**Date:** November 3, 2016

**Subject:** **Prairie Creek Mine, all season road undertaking 7 IR replies – PCA IRs**

This memo responds to PCA IR#2, 3, 8 and 10 from the proposed all season road undertaking 7 information requests.

**Attachment 2 Sections of the proposed all season road alignment within the Sundog Creek Riparian Area.**

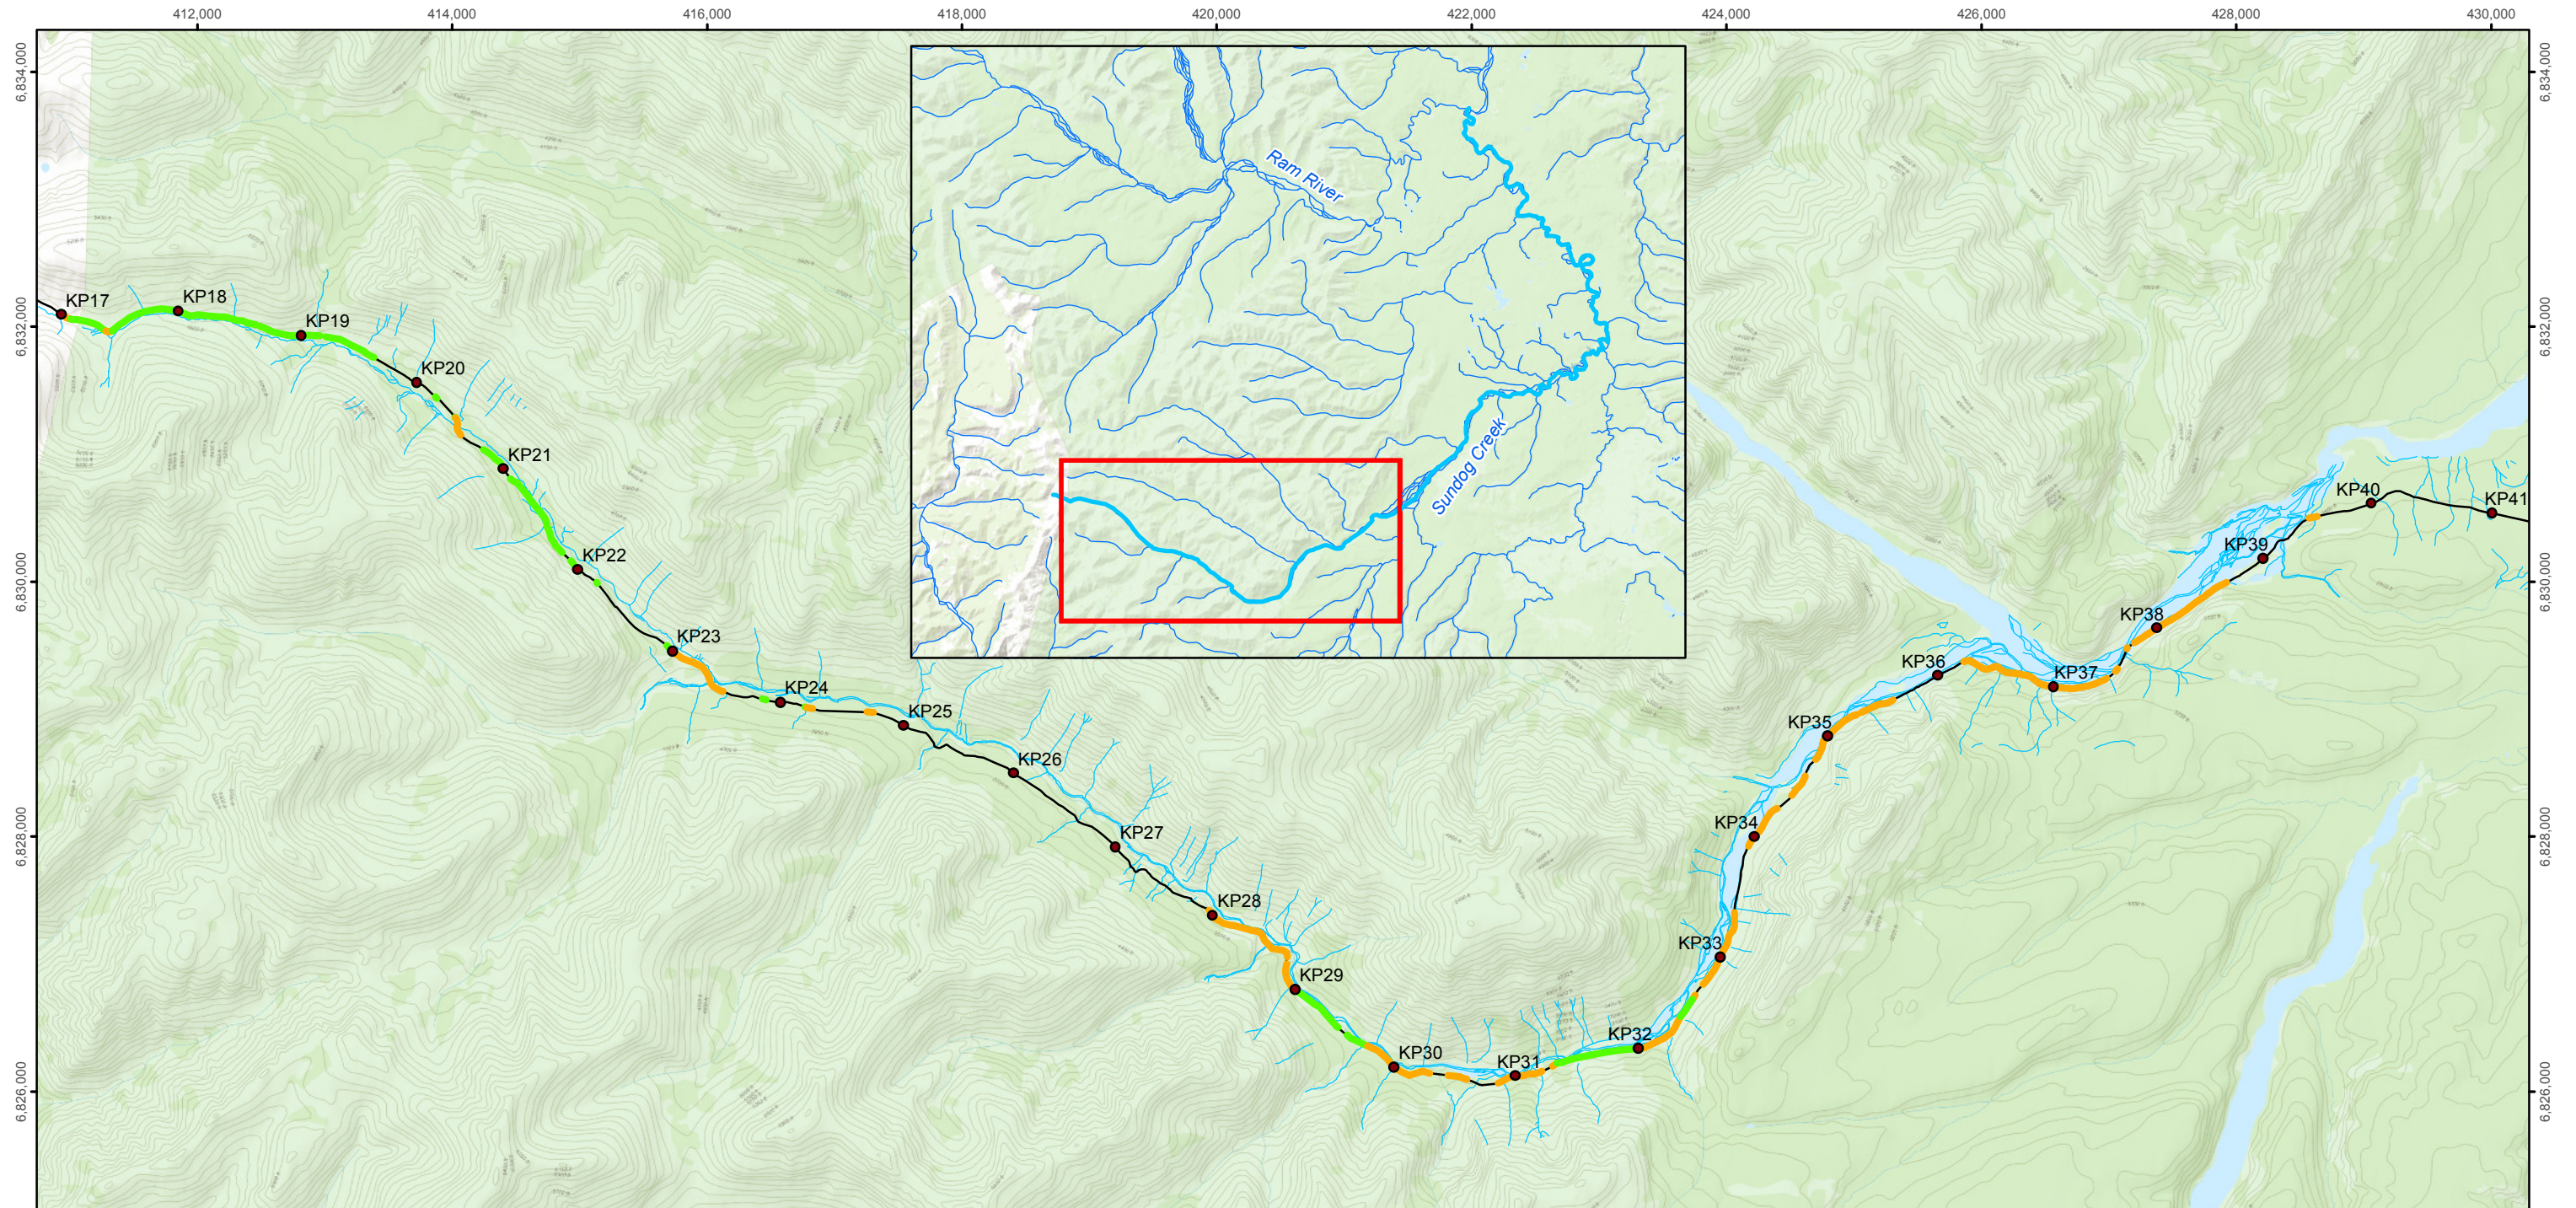
**Comment:** During the Technical sessions, there were three other short realignments where small portions the channel of Sundog Creek is On page 3 of a Hatfield Memo, dated September 6th, 2016, the proponent describes how the width of the riparian zone was determined and the criteria used to rank its level of importance (High, Medium, and Low). Tables later in the document contain estimates (m<sup>2</sup>) of the riparian habitat that will be lost for this project both permanently and temporarily. Lastly, the Memo states, on pg. 3, that the proponent believes “the loss of riparian vegetation will result in negligible loss of ecological function” and that the proponent does “not intend to directly offset these losses”. While we appreciated the work presented in the document, Parks Canada disagrees with the proponent regarding the ecological significance and the need to offset or restore impacted riparian habitat. The proponent’s statement regarding the loss of riparian habitat and resulting “negligible loss of ecological function” lacks scientifically based supporting references. The same can be said with regards to how the width and ranking of riparian habitat were determined. In addition, the ranking presented focusses solely on the significance of the riparian habitat for fish and gives no consideration to the other ecological functions it serves. Parks Canada is required to maintain ecological integrity and as such is compelled to consider all of the ecological structures and functions of riparian zones (see Gregory et al., 1991; Naiman and Décamps 1997; Pusey and Arthington 2003).

**Recommendation:** 1) Provide scientific literature which supports the conclusion “the loss of riparian vegetation will result in negligible loss of ecological function”; 2) Provide scientific literature that supports the method used to determine width of riparian zone; 3) Provide scientific literature to support the methodology used for ranking riparian habitat and which considers all of the ecological functions of the habitat; and 4) If the above results in a new riparian habitat categorization or ranking system, recalculate the amount of riparian habitat that will be lost, both temporarily and permanently, in each category/rank.

The portion of Sundog Creek paralleled by the all season road is approximately 23 km in length. Of this linear distance, approximately half is within the assigned 50 m riparian area (see map in Attachment 2). Approximately 40% of this follows the old winter road alignment, while approximately 60% follows a proposed new alignment. The proposed road runs through habitat that do not appear to be unique in the area; satellite imagery of Sundog Creek indicates six tributaries having a similar appearance to the branch paralleling the all season road. Based on satellite imagery, the riparian zone downstream of the road alignment, becomes denser and the gradient lower (as per Google Earth). These observations suggest more diverse habitat opportunities to fish downstream of the all season road. We feel it is highly unlikely that the removal of vegetation from the road prism will have any measureable impact on the aquatic ecology of Sundog Creek.
